ASSESSMENT REPORT

Section 75W Concept Plan and Project Modification Pad H Development – “Connect @ Erskine Park”, Erskine Park

Figure 3: Approved and Proposed Site H building arrangement including vehicle access points

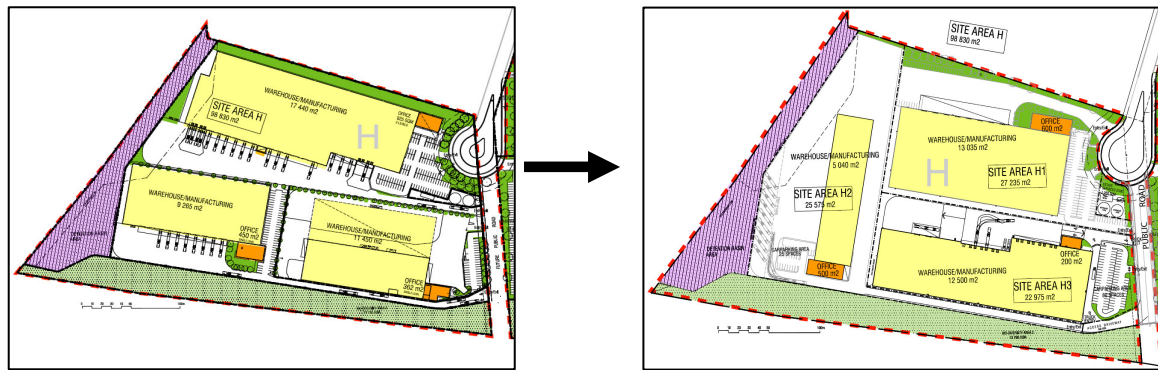
The proposed modifications involve altering the Concept Plan in relation to Site H, by reconfiguring the position of the three individual warehouses (see Figure 3).

GPT also proposed to modify the following on site as a result of the warehouse reconfigurations:

- the site access for the three warehouses, including 6 separate access/exit points for trucks and cars;
- changes to the landscape plan in accordance with the new building layout;
- modifications to the services connections and stormwater management; and
- extensions to Templar Road (to allow access to site H).

Council raised some concerns about the number of driveway access points on Templar Road, which has been considered further in Section 5 of this report and addressed through a condition of approval.

Issue	Key Impacts	Recommended Conditions
Vehicle Access	<ul style="list-style-type: none"> The proposal identifies the need for a total of six (6) access points where cars and trucks are physically separated to improve safety and to provide for operational requirements of the three separate users. GPT also proposes to extend Templar Road to allow for vehicle access to sites H1 and H3. Council raised some concern over the number of vehicle access points and the provision and maintenance of maximum sight distances for the safety of drivers. The Department met with GPT to discuss the issue and Council and GPT have now agreed that the driveways need not be amalgamated so long as maximum sight distances are maintained through signage and managing landscape vegetation. The Department has recommended conditions that require GPT to ensure that driveway access is designed to ensure that maximum sight distances are maintained, and furthermore to construct the extension to Templar Road to the satisfaction of Council. Council is satisfied that the recommended conditions would ensure that vehicle access is appropriate. 	<ul style="list-style-type: none"> The Department recommends that GPT shall, to the satisfaction of Council: <ul style="list-style-type: none"> ensure that the access driveways to Templar Road are designed to ensure maximum sight distance for entering and exiting vehicles, prior to the commencement of construction; ensure that signage and vegetation is not impeding sight distances from the access driveways to Templar Road; and construct the extension of Templar Road (within the Road Reserve as detailed in the existing consent).
